**BC BUILDING CODE INTERPRETATION COMMITTEE**  
**AIBC, APEGBC, BOABC, POABC**

**File No: 06-0055**

Fire separation of public corridors

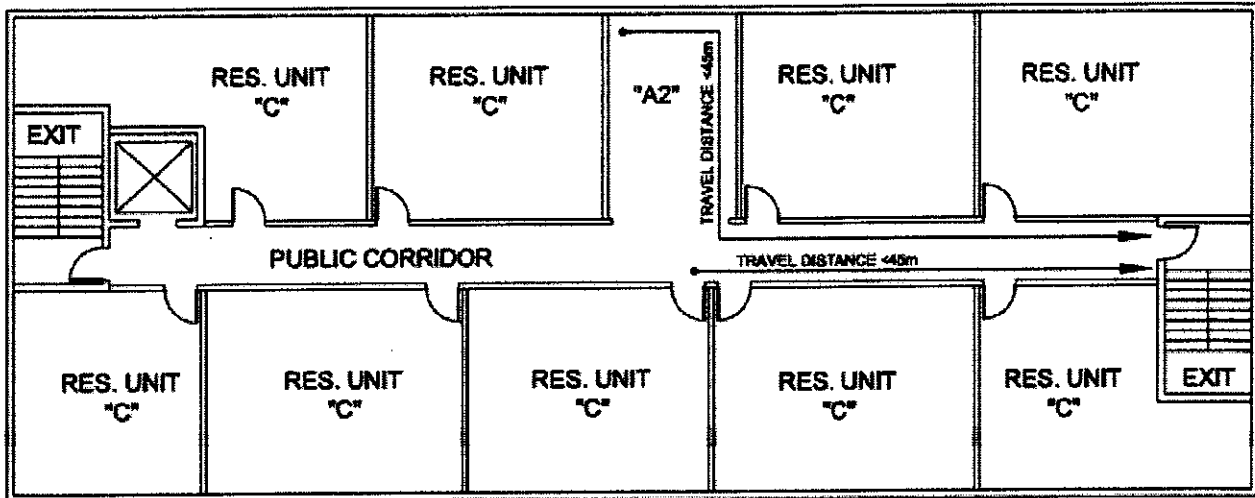
In a sprinklered residential building, is a fire separation required between a residential amenity room and a public corridor on a floor area where the public corridor serves both residential suites as well as the residential amenity room?

See attached drawing on Page 2.

No, provided the travel distance from any part of the floor area, including from within the residential suites, to the nearest exit is less than 45 meters.

Clause 3.3.1.4.(4)(a) waives the requirement for a fire separation between a room, other than a residential suite as described in Sentence 3.3.4.2.(1), and a public corridor provided that the travel distance from any part of the floor area to the nearest exit is less than 45 meters.

Sentence 3.3.4.2.(1) does not require any fire separation between a public corridor and a residential amenity room.
